# Impact on Traffic in Abingdon

of the Vale of the White Horse Local Plan

a topic report prepared

**The North Abingdon Local Plan Group**

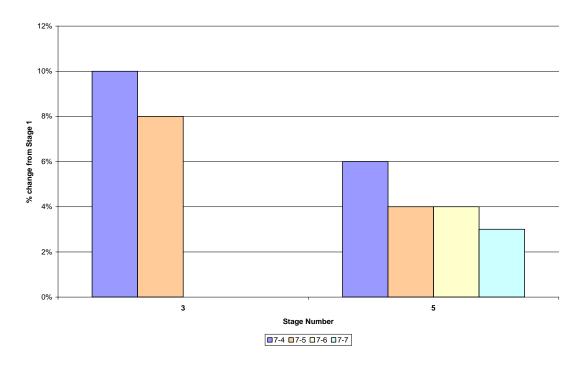
4.3. From the figure above displaying % delays to journey times as a function ETI stage number when compared to the base line ETI Stage 1, it can be seen that significant additional journey time delays are expected to be experienced with increased housing on both local roads and highways.

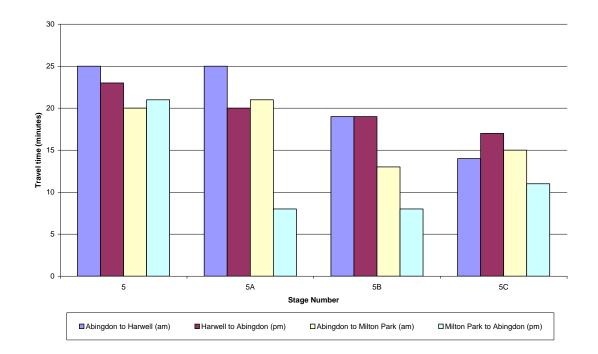
7.1.5. Details of Tables 7-4 to 7-7 are reproduced below in diagrammatic form summarizing the % changes in delays in journey time as a function of ETI Stage number – including the mitigation measures tabled above.

- From a comparison of Stage 5 with road mitigation options 5A, 5B and 5C, it can be seen that implementation of a second river crossing and widening of the A34 will significantly reduce traffic congestion. In a recent article in the Abingdon Herald<sup>10</sup>, Oxfordshire Growth Board leaders are reported to say that a third of journeys on the A34 are delayed (at present). However, the addition of a third lane in each direction on the A34 between Junction 9 of the M40 and the Chilton interchange would cost £800M.
- 7.1.7. The resulting impact on journey time between Abingdon and Harwell or Milton Park for outwards in the morning and return in the evening is shown in the figure below as a function of Stage number.
